APPLICATION NO.	FILING DATE	FIRST NAMED INVENTOR	ATTORNEY DOCKET NO.	CONFIRMATION NO.
10/621,317	07/18/2003	Ashvin D. Desai	87344.1524	2539

Office Action Summary	Application No. 10/621,317	Applicant(s) DESAI ET AL.	
	Examiner Matthew O. Savage	Art Unit 1724

FIG. 4

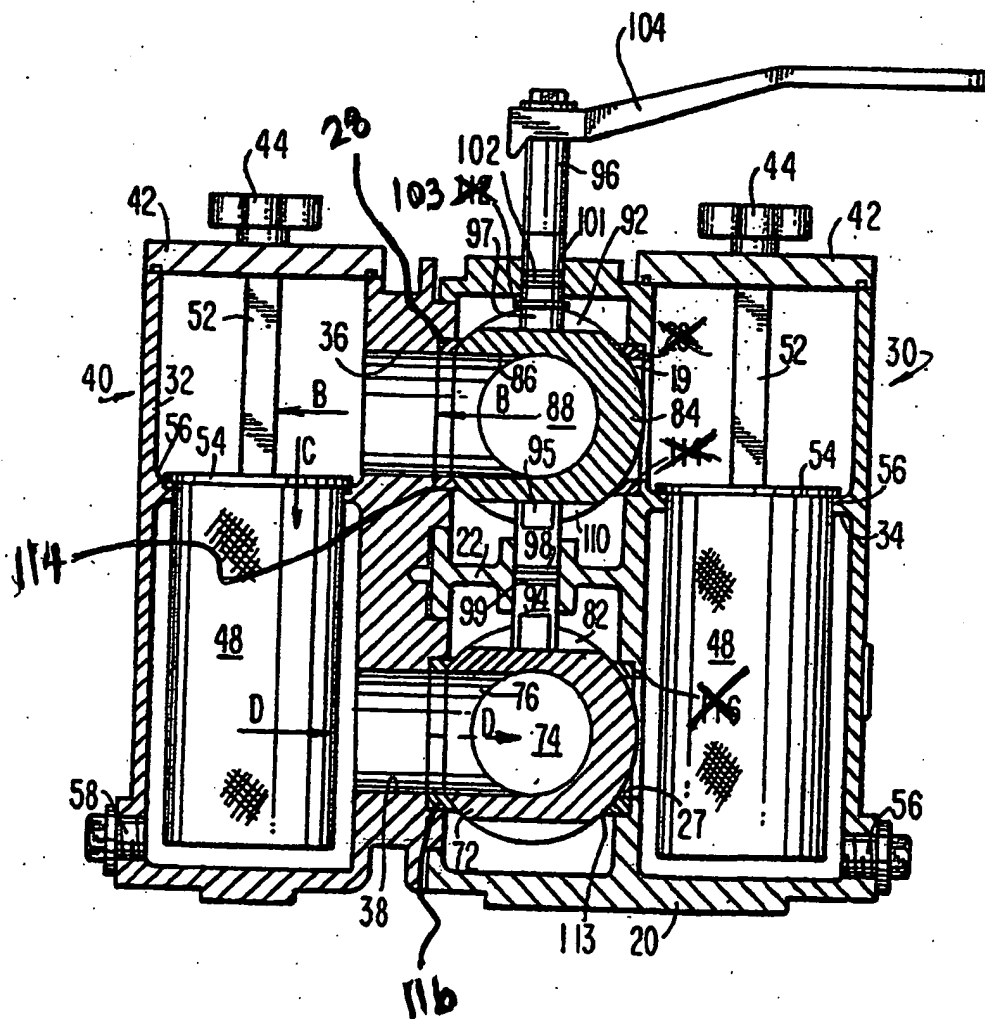
Applicant argues that the recitation of a first strainer chamber for straining and a second strainer chamber for straining provides sufficient structure for supporting the preamble, however, the associated rejection under 35 U.S.C. 112, second paragraph is maintained since it remains unclear as to how a straining function can be accomplished since no strainer structure has been recited in the claim. It is suggested that the body of all of the claims be amended to positively recite strainers (e.g., corresponding to the

structures 48 shown in FIG. 4) disposed in the respective strainer chambers to obviate the rejection.
